1990 - 1991 Corvette: Service Bulletin: 3-2 Coast Down Clunk

Subject: 3-2 COAST DOWN CLUNK (INSTALL SERVO SPRING)

Model and Year: 1990-91 CORVETTE WITH 4L60 AUTOMATIC TRANSMISSION

Bulletin Number: 91-372-7A - (06/27/1991)

Figure 1

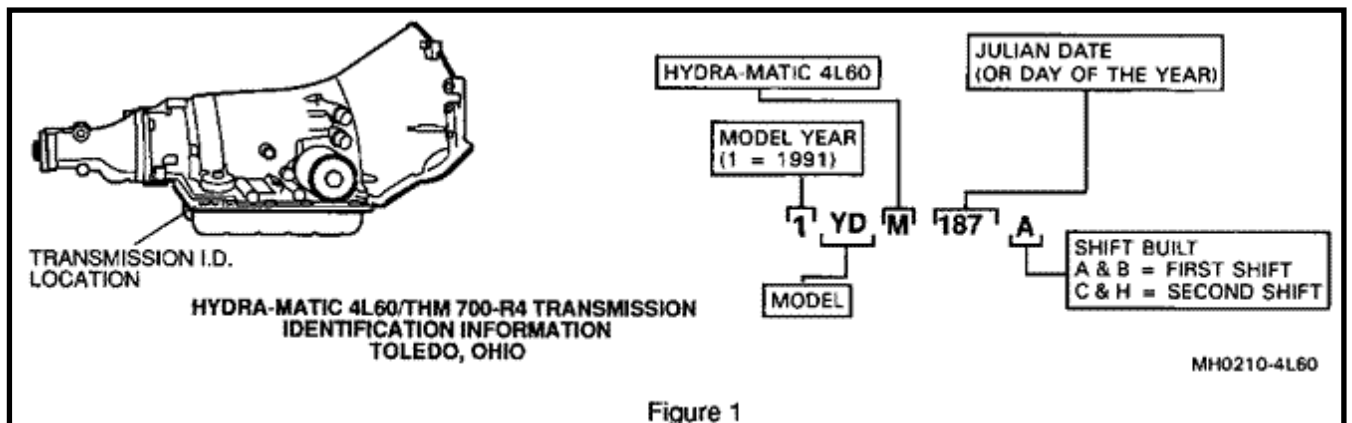
Date of Production Change: (Figure 1)

Beginning May 20, 1991 (Julian Date 140), all 1 YHM models of the HYDRAMATIC 4L60 were built using the new servo cushion assist spring and spacer plate.

Refer to Figure 2

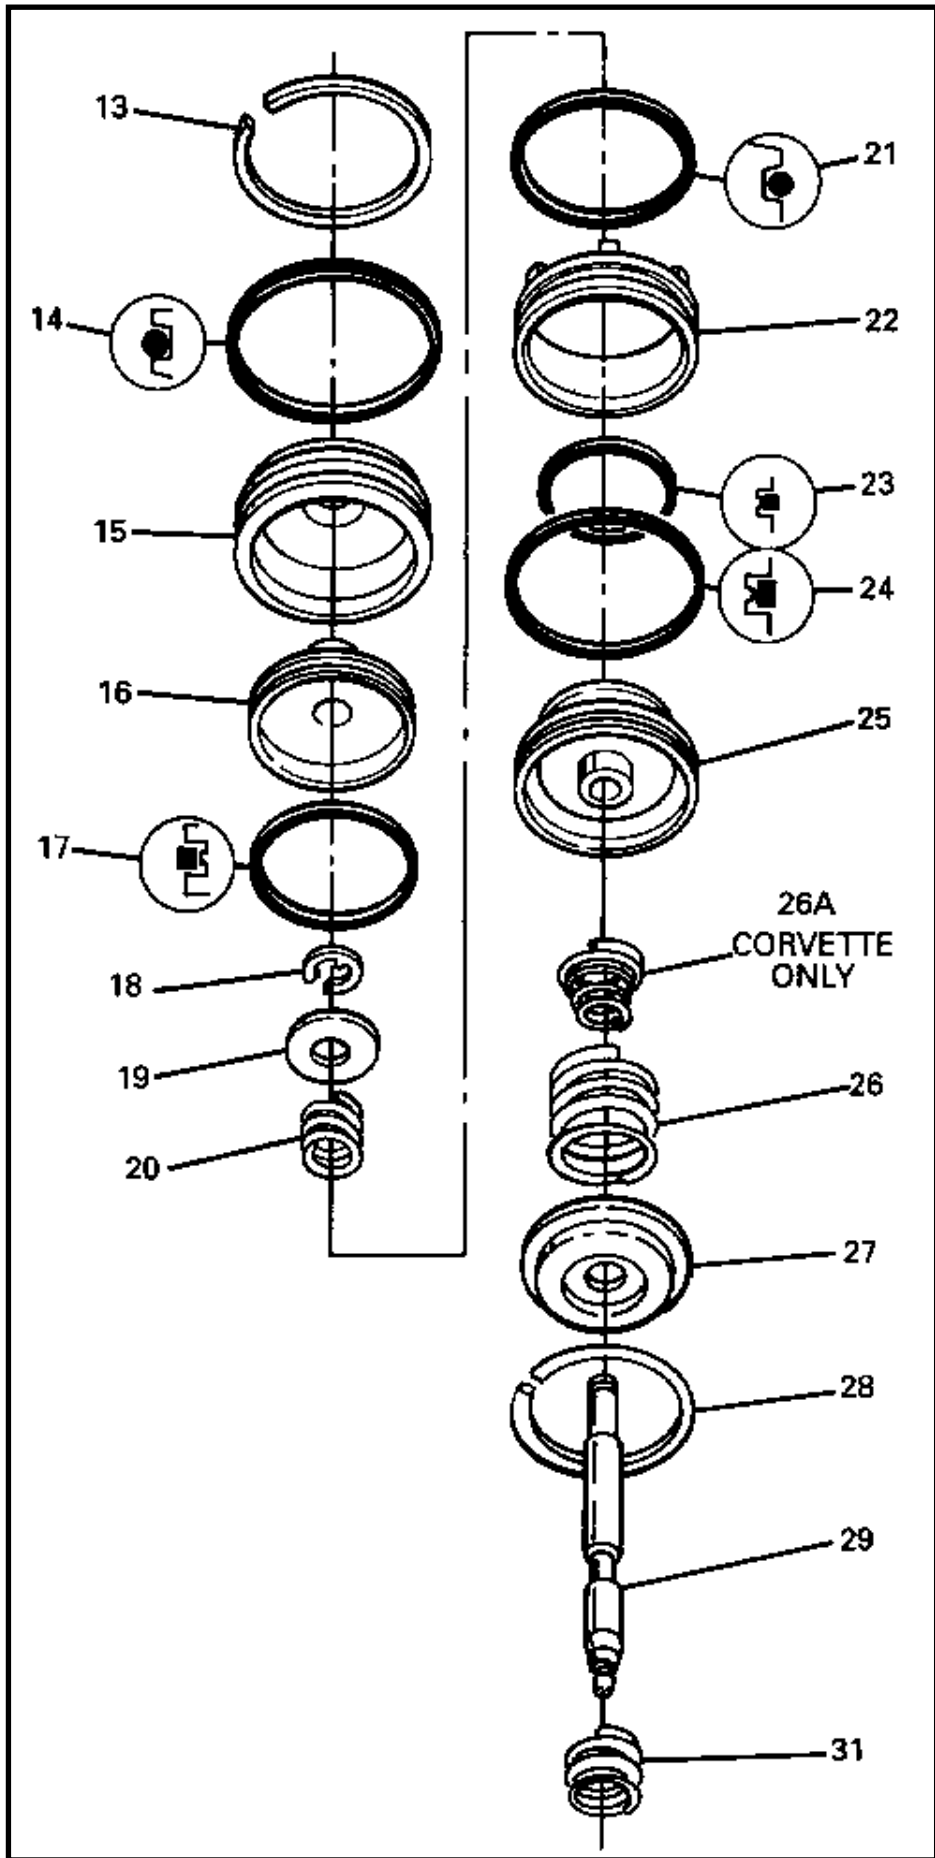
A new 2-4 servo cushion assist spring and spacer plate have been released to alleviate this condition. The new spring is a conical spring which nests inside the current 2-4 servo cushion spring. The new spacer plate has a modified third clutch exhaust orifice.

Install the new servo cushion assist spring inside the current servo cushion spring as shown in figure 2. Figure 2 shows the ONLY way the spring should be installed. Do not install the spring upside down. The new spring should not be used by itself.

Refer to the Automatic Transmission Unit Repair Section of the appropriate service manual for spacer plate removal and installation information. The 2-4 servo cushion assist spring is not shown in a service manual. Follow instructions for installing a 2-4 servo cushion spring, and add the servo cushion assist spring as shown in figure 2 of this bulletin.
